Proposal for draft 08 series of amendments to UN Regulation No. 107 (as adopted by GRSG at its 112th session)

Submitted by the expert from OICA

The text reproduced below was prepared by the expert from OICA to amend UN Regulation No. 107 to include transitional provisions into the amendments adopted at GRSG-112 per document GRSG-112-35, to improve the accommodation and accessibility for passengers with reduced mobility. The modifications to the current text of the 07 series of amendments to UN Regulation No. 107 are marked in bold characters for new and strikethrough for deleted characters.

4. Example of an integrating sphere according to CIE 38:1977:

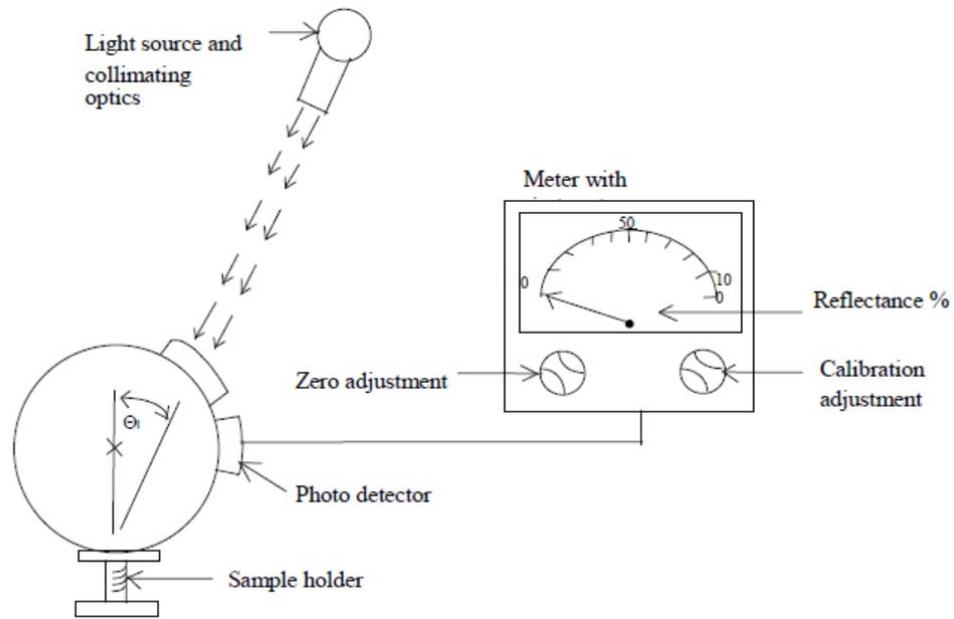
2. For determination of the reflectance values ρ_1 , ρ_2 and ρ_d an integrating sphere according to CIE 38:1977 shall be used.

The reflectance shall be either read directly from the indicating instrument or calculated according to the following formula:

- 2.1. The illumination angle of the luminous flux of the incident light on the sample Θ_i shall be equal to $8^\circ \pm 0.5^\circ$.

- 2.2. The luminous flux of the incident light on the sample shall be determined by using a diffuse reflectance standard calibrated by an accredited laboratory. The extended measurement uncertainty shall be lower than 3 per cent.
